**REVISION 004 TO A
REQUEST FOR PROPOSAL**

Title - Sujet : Restoration of the Cheewaht Lake Sockeye Tributaries – Pacific Rim National Park Reserve	
Solicitation No. - N° de l'invitation : 5P420-19-0173/A	Date : September 04, 2019
Amendment No. - N° de modification : 004	
Client Reference No. - N° de référence du client : n/a	
GETS Reference No. N° de reference de SEAG : PW-19-00883612

Amendment 004

Figure 1: Typical bank cross section showing bank slope, LWD, and live stakes. Note this is a generalized drawing and no cable will be used in the prescribed works.

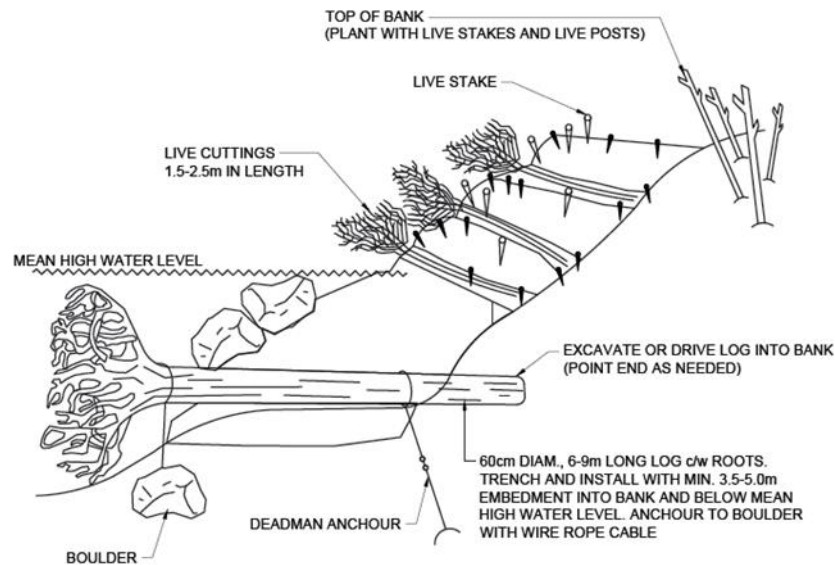
- Q11.** How was the estimated excavation volume of 11,000 m³ calculated? Are there designs or cross-sections for the prescribed stream excavation?
- A11.** The volume was estimated using prescribed cut depth, stream length and cross-section width. These drawings have been provided in section 3.3.6 of Annex A – Statement of Work.
